## MEMORANDUM

**SUBJECT:** Case 20975: Application by Boris Holdings Ltd. to substantively amend the existing development agreement for the subject site to permit a 6 foot by 6 foot ground sign on the Larry Uteck Boulevard street frontage for the benefit of commercial tenants.

**RE: Civic 540 Southgate Drive - Driver Sight Line Review**

## Case Number: 20975 Policy Review

**Figure 2: Proposed Sign Location Design Drawing**

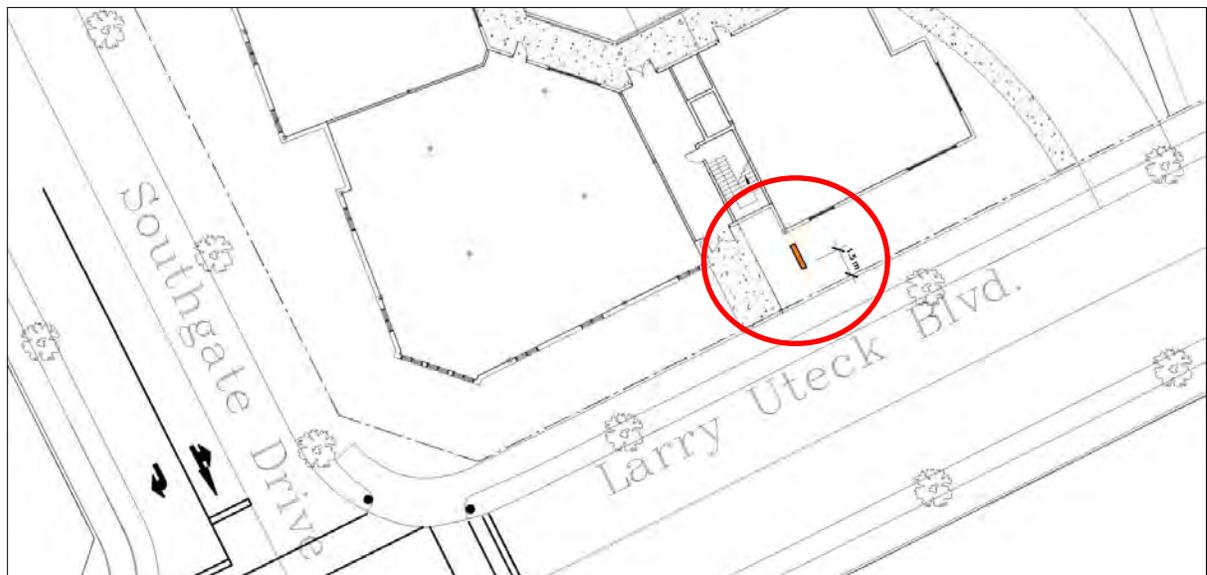
It was determined during the field review that the south edge of the proposed sign would need to be located at least 1m north of the sidewalk – and this formed the basis of the field measurements. Under these conditions, it was concluded that the available approaching driver sight distances measured in the field exceed minimum guidelines for drivers traveling along Larry Uteck Boulevard, given the expected vehicle operating speeds. Therefore, the proposed sign location shown in *Figure 2* with a 1.5m set back distance is not expected to negatively impact SSD.

Again, it was determined during the field review that a minimum 1m set back distance would be required between the south face of the sign and the north edge of the sidewalk. Under these conditions, the results indicate that the available TSD measured in the field, from both locations, exceed minimum guidelines. Therefore, the proposed sign location shown in *Figure 2* with a 1.5m set back distance is not expected to negatively impact TSD.

- The proposed sign was assumed to be located between the sidewalk and the civic 540 building, on the east side of the pedestrian walkway connecting the sidewalk and the front entrance. The south face of the sign will be set back from the north edge of the street right-of-way by a distance of 1.5m, as shown in *Figure 2*.

- Approach driver sight distances were reviewed in both directions along Larry Uteck Boulevard assuming the proposed sign is in place. It was concluded that the proposed sign location shown *Figure 2* will not negatively impact the existing available driver stopping sight distance (SSD) for a 60 km/h 85<sup>th</sup> percentile operating speed.

- Departure driver sight distances were reviewed from the perspective of Southgate Drive (right turn) and the east Plaza driveway (left turn) assuming the proposed sign is in place. It was concluded that the proposed sign location shown in *Figure 2* will not negatively impact or restrict the required driver turning sight distances (TSD), based on a 60 km/h 85<sup>th</sup> percentile operating speed.

- That the design of the freestanding monument sign provide at least a minimum 1m setback distance from the north edge of the sidewalk to ensure driver sight lines are maintained. The proposed design shown in *Figure 2* provides a 1.5m set back distance.
- That the design and installation of the freestanding monument sign comply with all of HRM's Zoning and By-law criteria including setback dimensions (i.e. setback away from the street right-of-way), intersection sight triangle and corner clearance distances to ensure both approach and departing driver sightlines are maintained.
